MEMORANDUM

To: Montgomery Township Planning Board

Re: **The Malvern School Properties, LP**
Preliminary and Final Major Site Plan
982 Georgetown-Franklin Turnpike (County Route 518)
Block 28010, Lots 57 & 58
H-C Highway Commercial Zone

Date: October 12, 2023

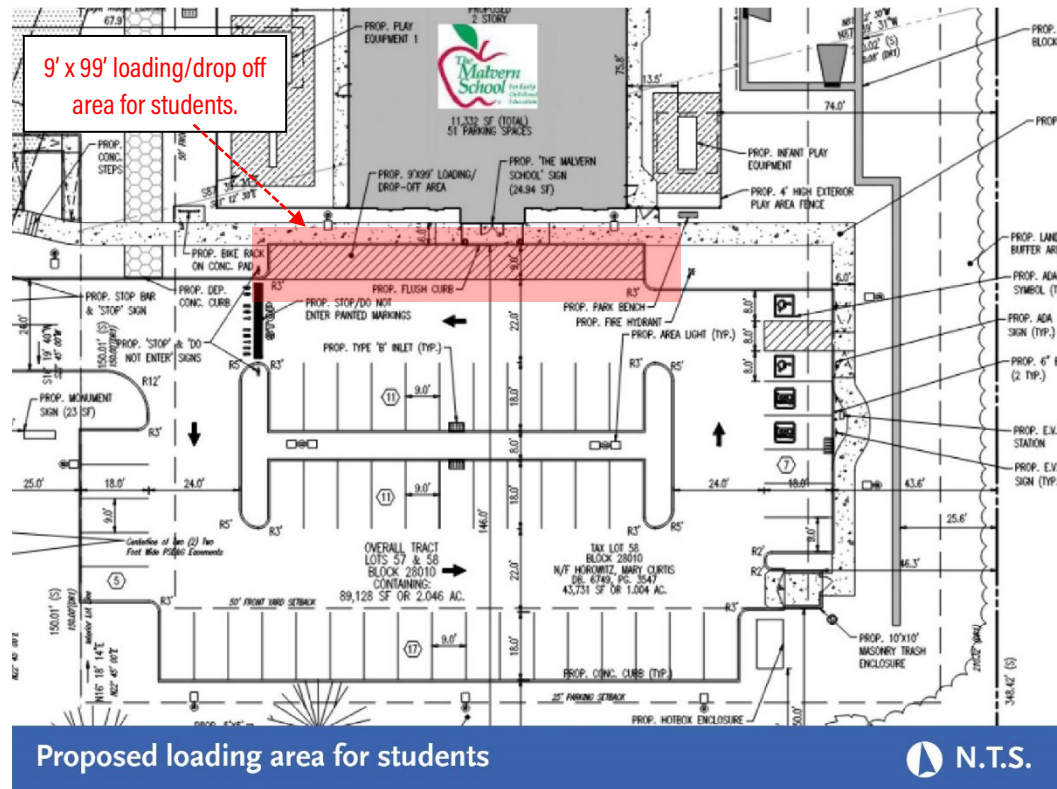
4.4. Parking and Loading Areas, Driveway and other Structure Distance: The plan complies. Per §16-4.12f.5, within the HC zone, no parking area, loading area, driveway, or other structure (except for approved access ways, signs and fencing) shall be permitted within the first 25 feet adjacent to any street line nor within the first 15 feet adjacent to any other property line. The plan complies.

4.4.1. Lawn Area Within Buffer. The plan complies. Per §16-4.12f.5 (the same regulation indicated in the preceding comment), the required distance between structures and the street line and adjacent property lines shall be planted and maintained with lawn or ground cover and trees and shrubbery as approved by the Board. The space between the parking area(s) and street contains lawn and plantings. The plan complies.

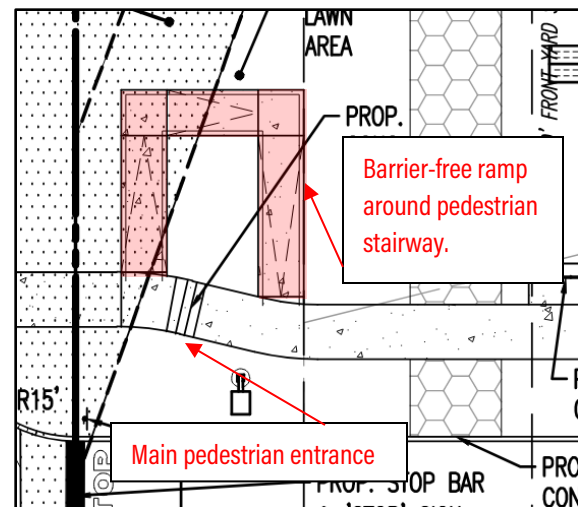
building(s) and between the principal building(s) and any existing, required or proposed sidewalk along a street. Sidewalks connect much of the site. The largest sidewalk is in an oval shape and connects frontages along Brecknell Way and CR 518 and wraps into the site, connecting in the deepest portion of the front yard setback. **The applicant should connect the southern portion of the parking area to the northern portion utilizing high visibility pedestrian striping. Additional pedestrian infrastructure may be required by the Board to meet this requirement.**

- 5.7. **Barrier-Free Ramp:** The applicant is proposing a barrier-free ramp that provides accessible access around the proposed concrete steps leading into the site. The grading plan indicates that the ramp declines approximately two feet leading into the site, and conversely inclines two feet upon leaving the site, at a length of ± 52 feet. The sidewalk entrance from Brecknell Way leading to the front of the building is 142 feet and contains a slope of $\pm 3.2\%$. **This office recommends that the sidewalk be reconfigured such that the concrete steps are eliminated, and the sidewalk contain a gentle slope, and that the sidewalk be universally designed to accommodate individuals with mobility issues without the need for the 52-foot ramp.**

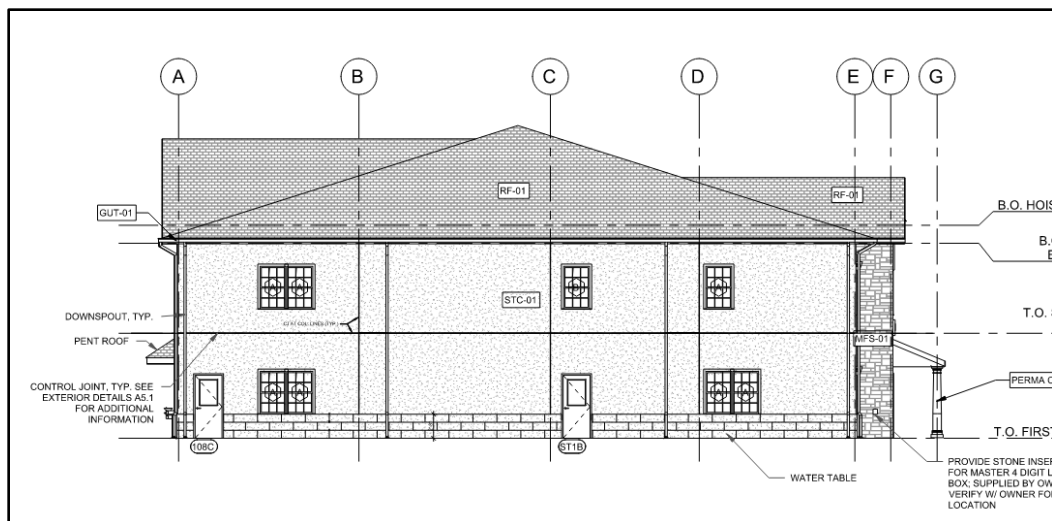
11.5. Pedestrian Scale: §16-4.12e.1(b) requires that architectural details, style, color, proportion and massing shall create a pedestrian scale development. The front entrance of the childcare facility front entrance is of a pedestrian scale, as are

the heights of the habitable stories of the building. The size and proportions of the windows and the doors are at a pedestrian scale. The canopy overhang is pedestrian friendly as it provides protection from the elements.

- 11.6. Building Entrances:** The plan complies. §16-4.12e.4(a) requires that all entrances to a building shall be articulated utilizing architectural elements such as lintels, pediments, pilasters, columns, porticoes, porches, or overhangs. Such elements shall be architecturally compatible with the overall building. As indicated in 10.3, the design of the childcare facility does comply. As indicated in 10.3, the design of the childcare facility does comply.
